# **Christmas Creek Expansion Public Environmental Review – Response to Public Submissions**

**Christmas Creek**

**25 September 2015  
CC-RP-EN-0120**

Figure 9 – Water Management Scheme ARI Groundwater Level Change

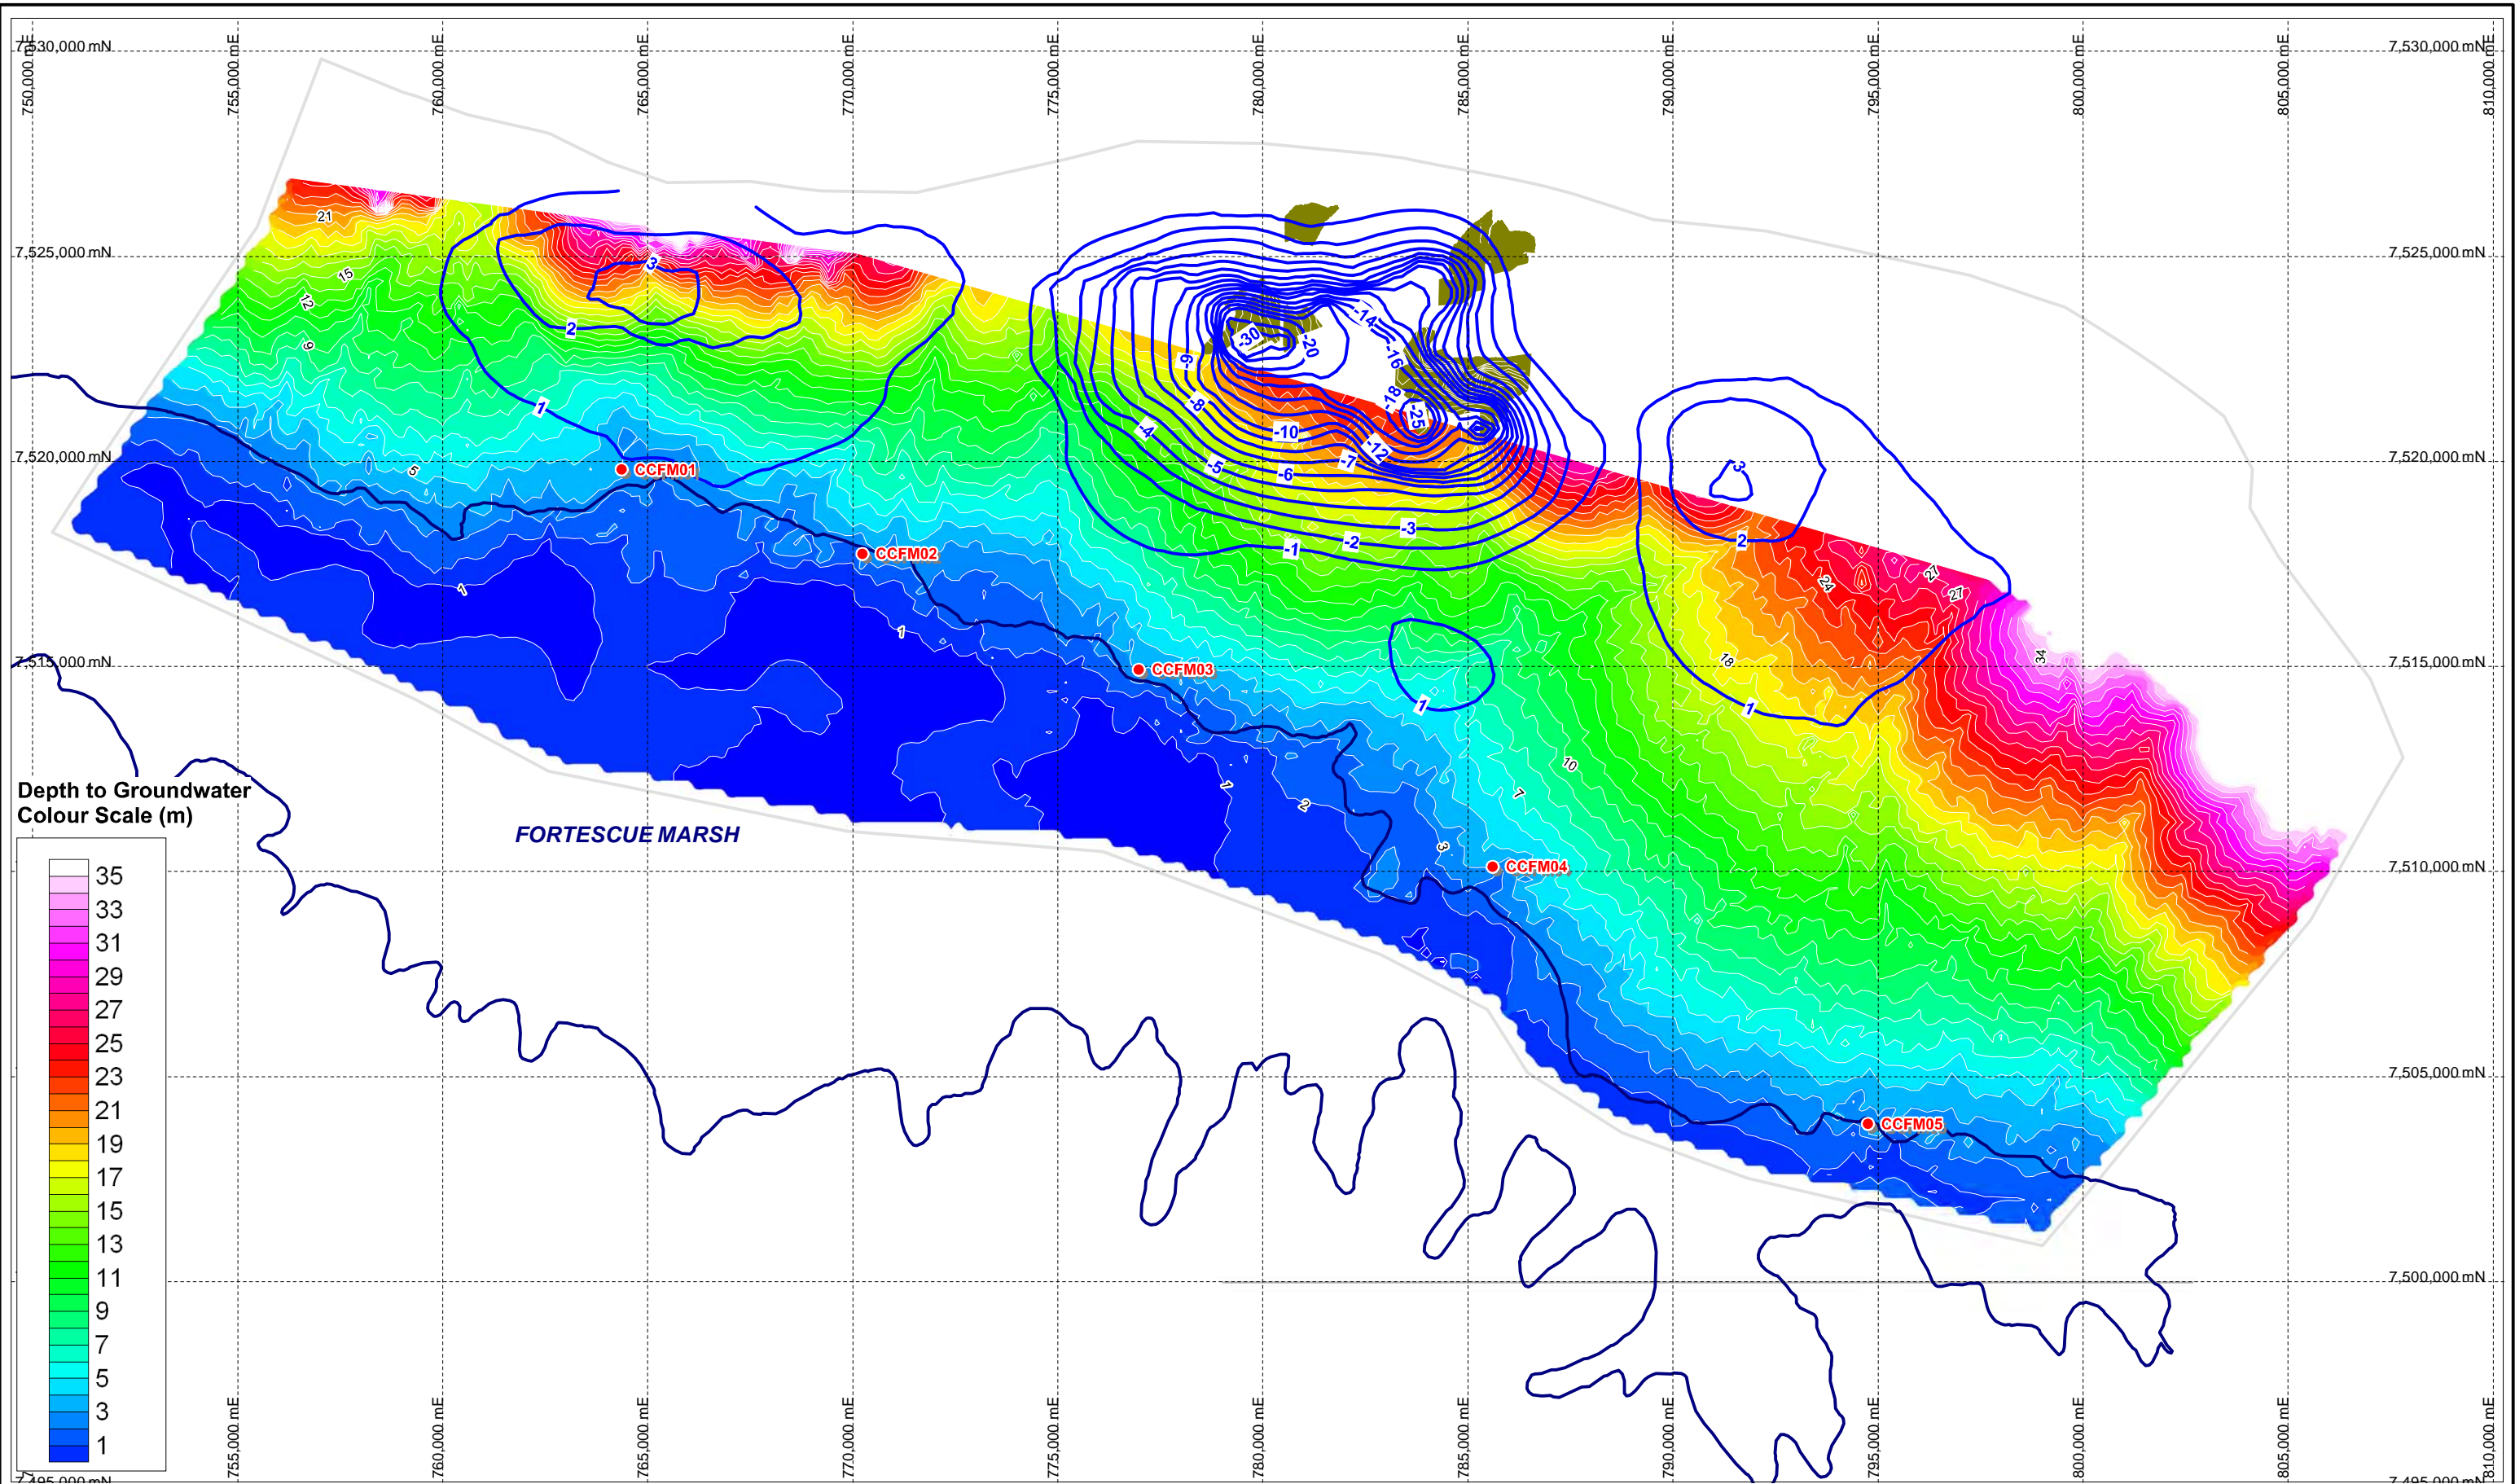
Item	Submitter	Submission and/or issue	Response to comment																																																												
3.1	Department of Water (DoW)	<p>Groundwater</p> <p>The groundwater modelling uses average predicted dewatering and injection volumes over the period 2014 to 2028 of 30.4 GL/a (no injection) and 40.5 GL/a (with injection) - with a peak annualised dewatering demand of 73.5 GL/a (with injection) in the year ending June 2015. It is unclear if FMG intend to adhere to the dewatering amounts used in the modelling or increase dewatering to 110 GL/a. It is also unclear what the dewatering and mounding response would be to a sustained 110 GL/a dewatering and injection scenario (with use of up to 35 GL/a).</p> <p>FMG should provide clarification on their intended dewatering and injection regime over the Life of Mine. In addition, FMG should clarify what dewatering sand mounding response is anticipated, should the dewatering and injection regime vary considerably to the dewatering volumes used in the modelling. This information should be provided for assessment, before the DoW can confirm potential impacts have been adequately assessed.</p> <p>DoW will review the Christmas Creek (and Cloudbreak) Groundwater operating strategy (GWOS) to ensure that the bores proposed to be used to monitor water quality to monitor for possible acid metalliferous drainage are suitable and included in the strategy / strategies.</p>	<p>The hydrological modelling presented in the Christmas Creek Iron ore Mine Expansion Public Environmental Review (PER) was undertaken during 2013, resulting in the first year of the model being 2014. The basis of the model was that the expansion mine plan and dewatering would commence simultaneously resulting in the initial peak water abstraction presented in Table 17 of the PER. However the peak water abstraction is now forecast to occur in 2017, with the same trend as to that presented in the PER albeit delayed by two years (Chart 1).</p> <p><b>Chart 1: Revised modelled annual water abstraction hydrograph.</b></p>

<p>The current operations dewatering performance is consistent with the hydrological modelling undertaken for the current Water Management Scheme (WMS) assessment (MS871). Figure 9 (attached) was presented in the WMS API supporting document (CC-RP-HY-0004) in 2010 illustrating the predicted areas drawdown for 2015. The drawdown presented in Figure 9 has been converted to groundwater levels (Figure 13) to allow for comparison with Figure 10. Figure 10 (attached) was prepared for the recently published <i>Christmas Creek Groundwater Monitoring Summary, 1st February – 30th April 2015</i> (CC-RP-HY-0053) and represents the current groundwater levels which are consistent with those modelled in 2010, which provides confidence in numerical modelling and their predictions.</p> <p>Figure 21 of the PER illustrates the modelled groundwater drawdown in year 1 of the implementation of the Proposal. The figure details the area of groundwater drawdown extending eastwards as new mining areas are developed. This follows the mining sequence presented in PER Figure 11. It is the development and commencement of dewatering to the east, in combination with existing operations, which combine to simulate the peak dewatering (potentially up to 110GL with consideration of parameter and climatic sensitivity) in the early years of the proposal.</p> <p>The modelled drawdown predicted for mining year 14 (PER Figure 25) has resulted from the mining sequence continuing eastwards and mining pits being developed in the western region of the proposal towards the end of the 14 mining years of the proposal. This presents a worse case situation for dewatering drawdown, where mining and hence dewatering is required across the full strike length of the ore body which produces a large elongated cone of depression. It is predicted the annual volume of water abstracted will decline in the latter years of the model (Chart 1) and groundwater levels begin to rebound (PER Figure 25).</p> <p>The modelling and sensitivity analysis undertaken by Fortescue (PER Appendix 5A) demonstrates the boundary of the dewatered zone is influenced by the area of dewatering operations and the average dewatering rates; as opposed to peak</p>	Model Year	Base Case	Dry Scenario	Wet Scenario	High Ore Body K	Low Ore Body K	2015	50	50	50	65	40	2017	75	70	65	110	55	2019	35	35	35	55	25	2021	45	45	45	65	35	2023	45	45	45	55	35	2025	55	55	55	85	45	2027	25	25	25	35	20	2029	20	20	20	25	15	2031	15	15	15	15	10
Model Year	Base Case	Dry Scenario	Wet Scenario	High Ore Body K	Low Ore Body K																																																										
2015	50	50	50	65	40																																																										
2017	75	70	65	110	55																																																										
2019	35	35	35	55	25																																																										
2021	45	45	45	65	35																																																										
2023	45	45	45	55	35																																																										
2025	55	55	55	85	45																																																										
2027	25	25	25	35	20																																																										
2029	20	20	20	25	15																																																										
2031	15	15	15	15	10

Figure 11 – Christmas Creek 1m Drawdown Contours

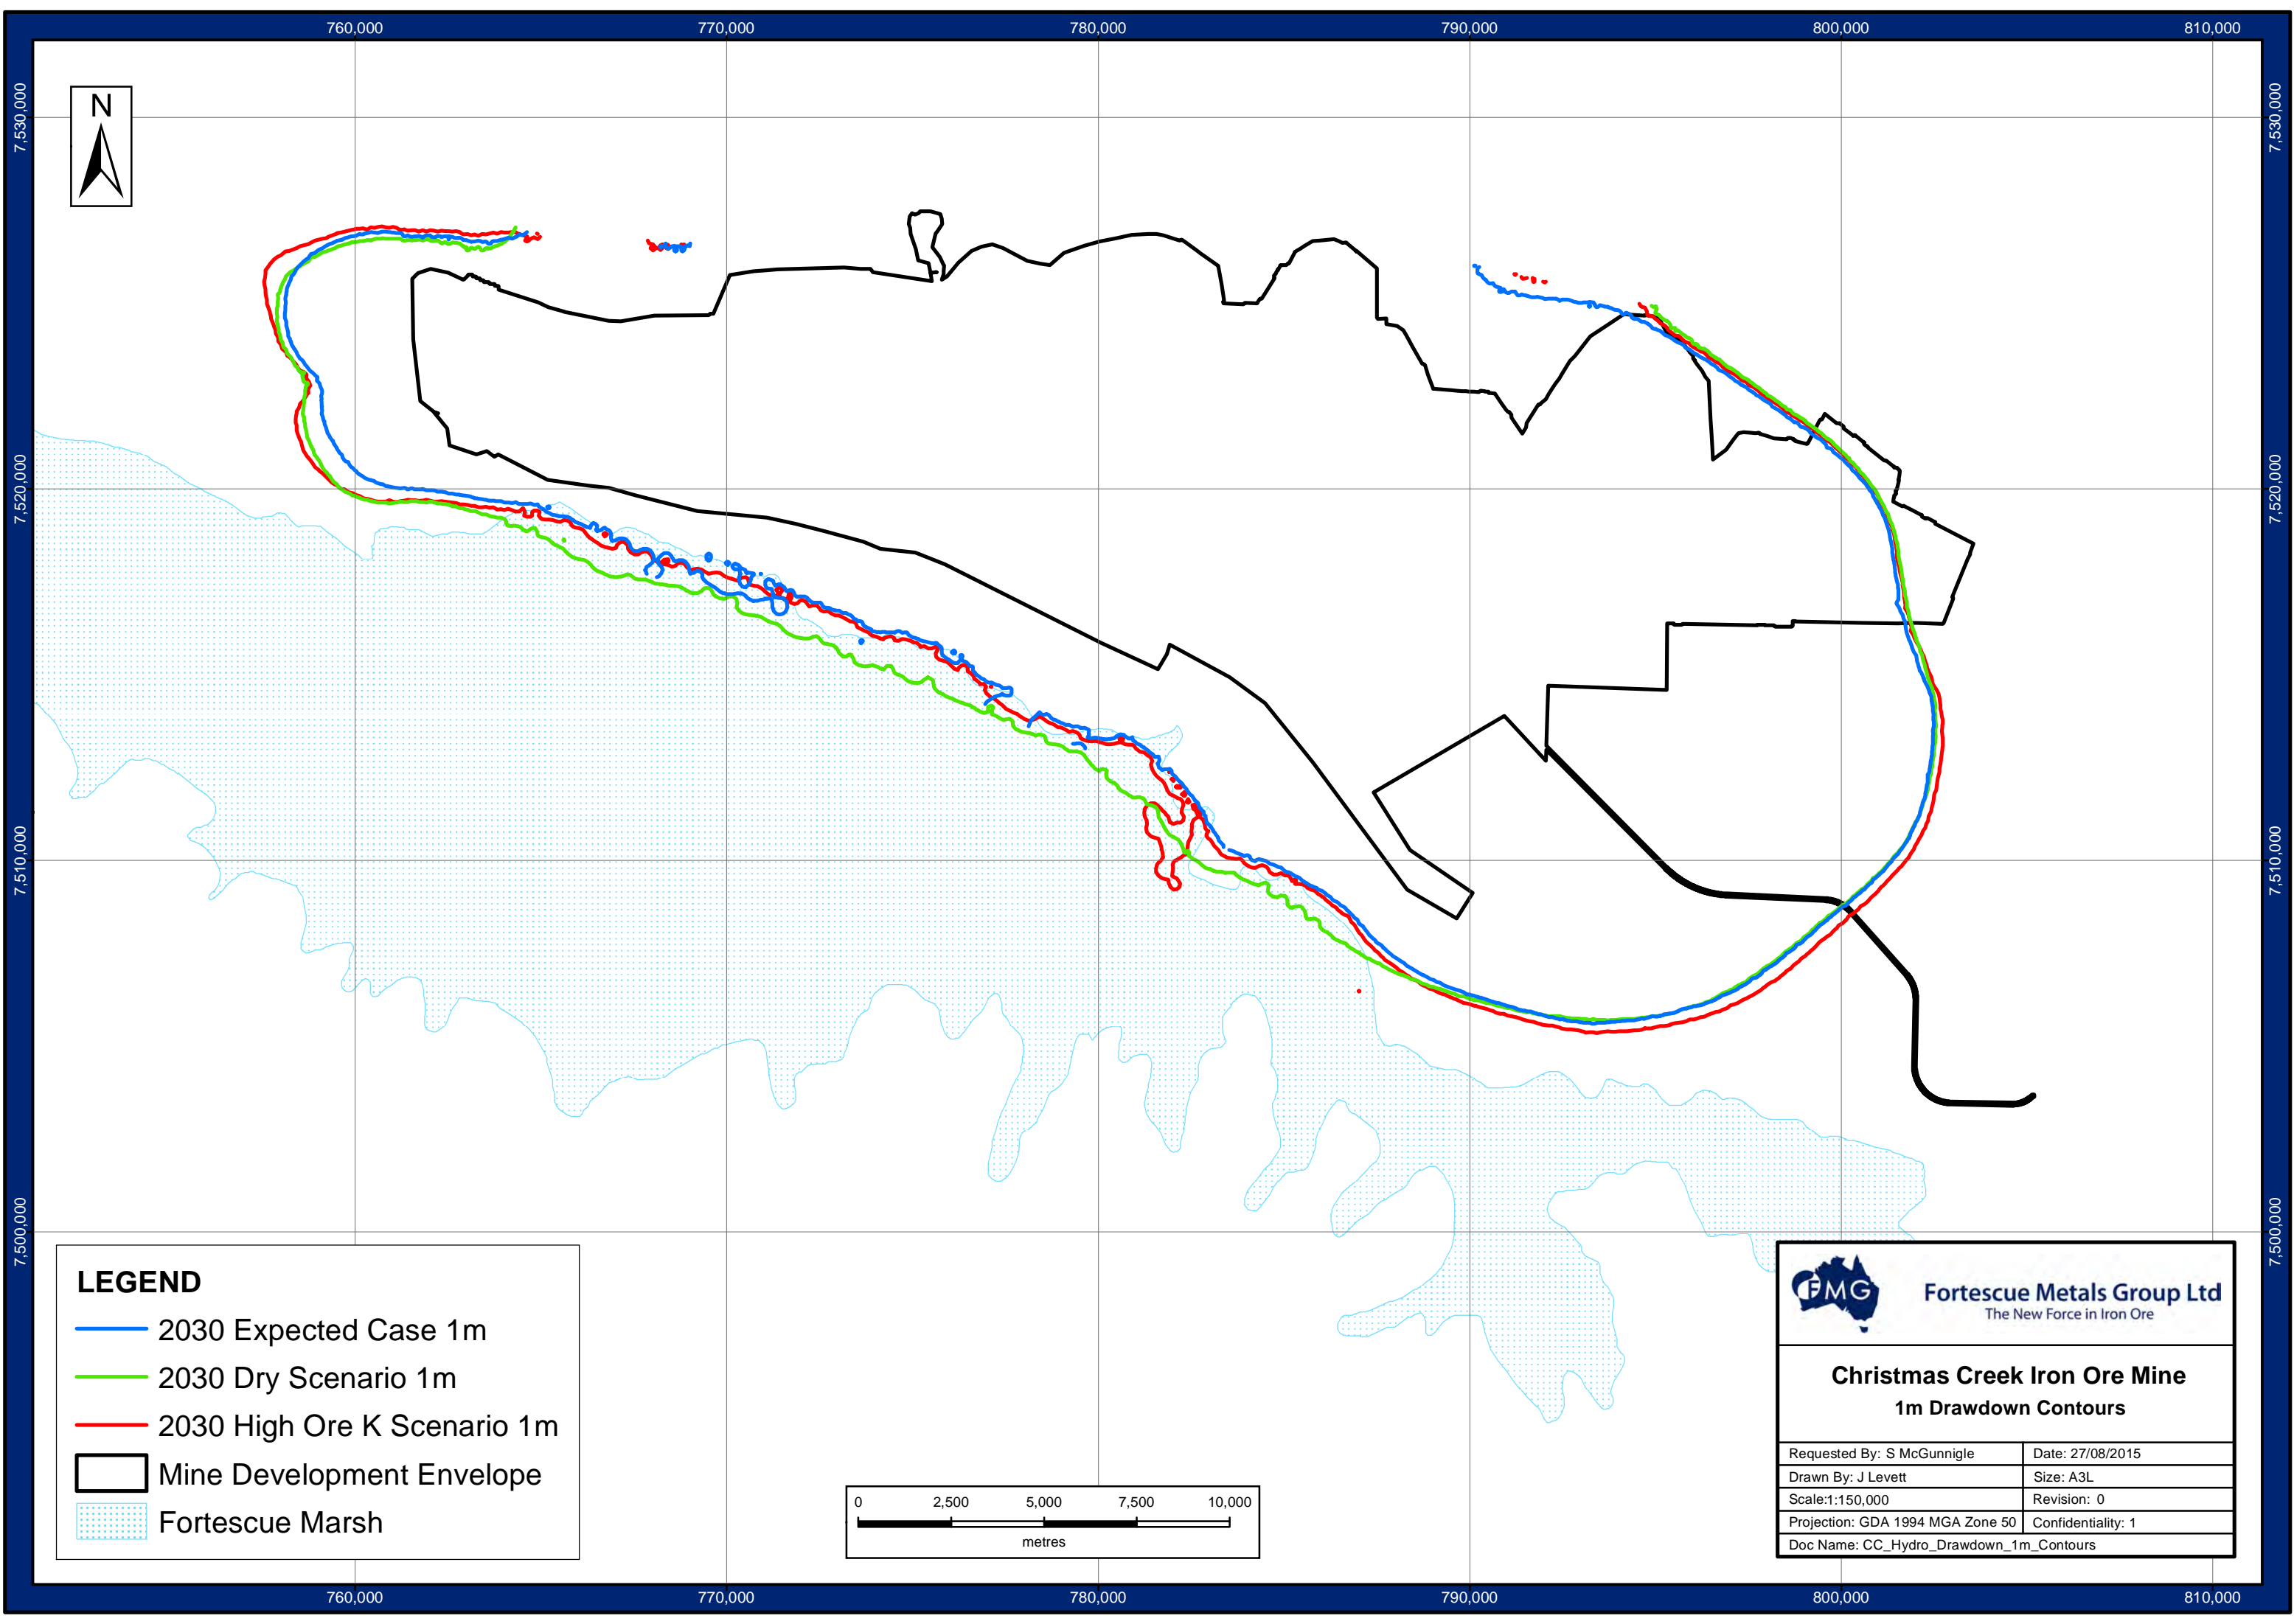
Item	Submitter	Submission and/or issue	Response to comment
3.10		<p>Groundwater dependent vegetation</p> <p>FMG are proposing an average annual dewatering volume of 40.5 GL/a and reinjection of 30.8 GL/a. The modelled drawdown of the Christmas Creek Expansion is predicted to lower the groundwater levels of RHIO tenement M46/519 (figures 21 to 28). The potential environmental impact is a decline in health of groundwater dependent vegetation (GDV) - RHIO is required under condition 6 of MS 824 and 826 to monitor vegetation health across its mine site in association with groundwater drawdown associated with mining and dewatering activities within mining tenements M46/518 and M46/519.</p> <p>The modelled drawdown from the Christmas Creek Expansion dewatering activities are predicted to lower groundwater levels of tenement M46/519 and in the areas of potential ground water dependent vegetation.</p> <p>The additional drawdown and duration of the drawdown of groundwater in the vicinity RHIO tenure may result in the decline in health of the vegetation within the RHIO tenements not associated with RH activities.</p>	<p>Fortescue agrees that groundwater drawdown associated with the Proposal will impact groundwater levels within neighbouring mining tenements. Section 7.7.2 of the PER addresses the overlap in mine dewatering areas of impact between Christmas Creek and RHIO. Figure 37 illustrates the overlapping groundwater drawdown contours and details that dewatering associated with RHIO proposal will impact areas with Fortescue's tenements.</p> <p>As stated in Section 9.7.2 of the PER "Areas where depth to groundwater is less than 5 m without mining occurring and drawdown of greater than 2 m is expected have been mapped on an annual basis and are presented in Figure 47 (2014) to Figure 61 (2028) to determine areas of indirect impact to GDE vegetation (VT01). A small area of VT01 in the southern part of the Survey Area is expected to be affected. This impact commences in 2026 and is expected to continue until 2028. Figure 62 shows the extent of indirect impact areas to VT01 for all years combined. The area of indirect impact to VT01 is 1.1 ha at its largest predicted extent".</p> <p>The area of impact depicted in the PER is located on the southern boundary of the Proposal. The closest area of potential impact to the RHIO tenement is approximately 5 km.</p> <p>Fortescue has also committed to the ongoing implementation of the <i>Vegetation Health Monitoring and Management Plan</i> (CC-PL-EN-0004) to identify and manage any potential indirect impacts to vegetation associated with the implementation of the Proposal.</p> <p>Fortescue has committed to the ongoing implementation of the Stakeholder Consultation ReInjection Management Plan, (CC-PL-EN-0006, PER Appendix 2A). Fortescue proposes Fortescue and RHIO continue consultation on groundwater management through the Chichester Joint Water Management Group.</p>
